# UNITED STATES DEPARTMENT OF THE INTERIOR BUREAU OF LAND MANAGEMENT

SUNDRY NOTICES AND REPORTS ON WELLS
Do not use this form for proposals to drill or to re-enter an
abandoned well. Use form 3160-3 (APD) for such proposals

# Patron 23 Federal 2H - Sundry (WIS # 304763)

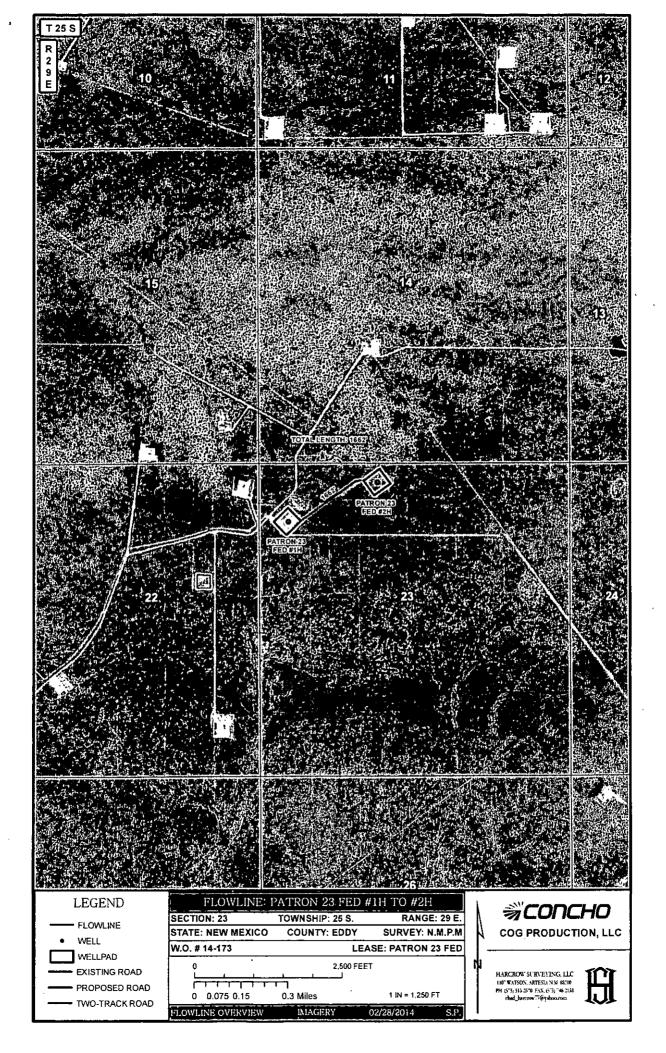
The route you show in the original Sundry shows the proposed pipeline routes to cross the two-track diagonally. What I'm looking for is to route the line along the existing two-track that, admittedly is a little difficult to distinguish on an aerial map. Feel free to give me a call at 575-234-5943 if you're not seeing what I'm attempting to describe.

The EA for this well states that there is a flow line that is currently planned to be installed within an existing two-track connecting the two well pads. The ROW # for this is 24619. We can use this existing two track to install the two new surface lines without obtaining a new ROW and re-routing. Can you show this as the proposed location within the sundry on a diagram similar to the one you just provided?

I see the roadway between the 2H and the 3H pads but did not see a roadway between the 2H and 1H pads proposed in the 2H APD, or in this diagram.

Regarding the referenced Sundry, can you please provide me with a diagram showing existing access roads for the other Patron 23 wells in the area? All proposed lines must follow existing disturbance (roadway or access road).

- Please indicate the type of fluid within the proposed 3" steel surface line
- Please provide the anticipated fluid pressure for each proposed pipeline.

Attached is the map of the access road from the Patron 23 Federal #2H to the #1H, this is the approved route for the flowline in the Surface Use Agreement in the APD, I saw the map of the flowline going across country (also in the APD) and thought that was the approved route, sorry for the confusion. There will not be a tank battery on the Patron #2H so the flowline will carry production to the battery on the Patron #1H, the other line is a gas line to carry gas back to the Patron #2H for artificial lift. Line pressure will be less than 125 psi for both lines.

The surface pipeline must be installed no farther than 10 feet off the two-track road/pipeline righ-of-way for most of the route when the new pipeline follows the existing buried pipeline easement.
